To: TSG RAN WG2
Source: TSG RAN WG1
Title: Answer to Liaison statement on TS 25.302, 'Services provided by the Physical Layer'

WG1 thank WG2 for their Liaison statement on 25.302, Services provided by the Physical Layer' (TSGR1#6(99)965 & TSGR2#5(99)700) and would like to give the following comments on TS 25.302 V2.4.0:

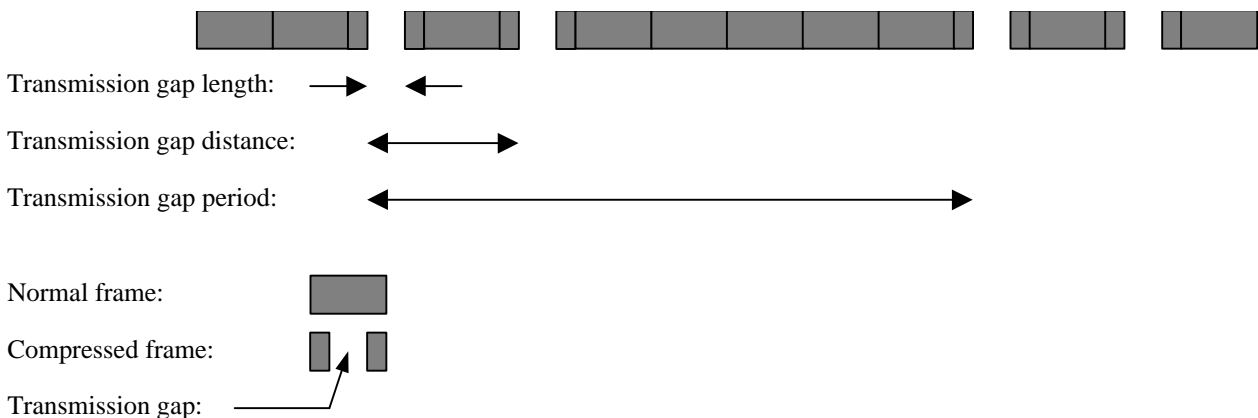
WG1 would like to inform WG2 that the terminology "slotted mode" is no longer used within WG1. Instead "compressed mode" is used since that describes more what is actually done, i.e. the data is compressed in time to create a measurement hole. The radio frames that are compressed should then be denoted "compressed frames".

The actual gap in the transmission created in the compressed frames, should be called "transmission gap". The length in time of this gap is then denoted "transmission gap length". In a pattern of compressed frames, the "compressed frame pattern" there may in the general case be more then one compressed frame. The distance between those frames is the "transmission gap distance". There may be, in the general case, different transmission gap distances between different compressed frames in the pattern. The distance between the patterns of compressed frames is the "transmission gap period".

The general case with patterns of compressed frames is shown in the figure below.

To summarise, WG1 would like to ask WG2 to modify the terminology used within WG2, so that there is consistency between the groups. The terminology used should then be: compressed mode, compressed frame, compressed frame pattern, transmission gap, transmission gap length, transmission gap distance, transmission gap period.
